Proposal for amendments to GRE/2018/33 (LSD)

Submitted by the expert from the International Motorcycle Manufacturers Association*

Proposal for Supplement 1 to the original version of the UN Regulation on Light-Signalling Devices

Visibility angle for rear position lamps
(for a pair of lamps)

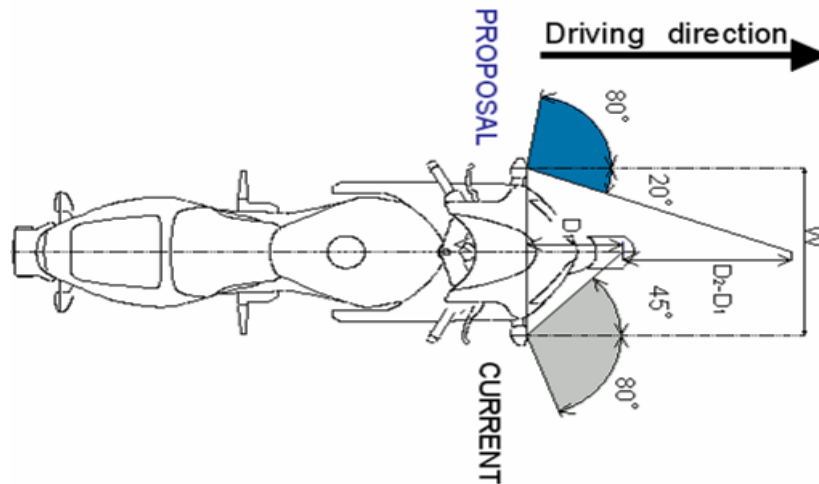
5. Following documents has been so far submitted to GRE on this issue:
 GRE/2018/27 on R50 -> GRE/2018/33 on LSD
 GRE/2018/28 on R53
6. IMMA has proposed to change the horizontal rear inboard visibility angles, as follows, regardless of the mounting height. No change to the vertical angles were proposed.

Mounting height	Device (R50/LSD)		Installation (R53)	
	< 750	>= 750	< 750	>= 750
Current	V +15/-5	V +15/-10	V +15/-5	V +15/-15
	H +80/-45 above H plane H +80/-20 under H plane	H +80/-45	H +80/-45	
Proposed	V +15/-5	V +15/-10	V +15/-5	V +15/-15
	H +80/-20		H +80/-20

7. IMMA has proposed to change angles of the rear position lamps, to align them with the angles of the front position lamps. The effect of the inward angle difference between 20 deg / 45 deg is negligible in terms of visibility /visibility distance.
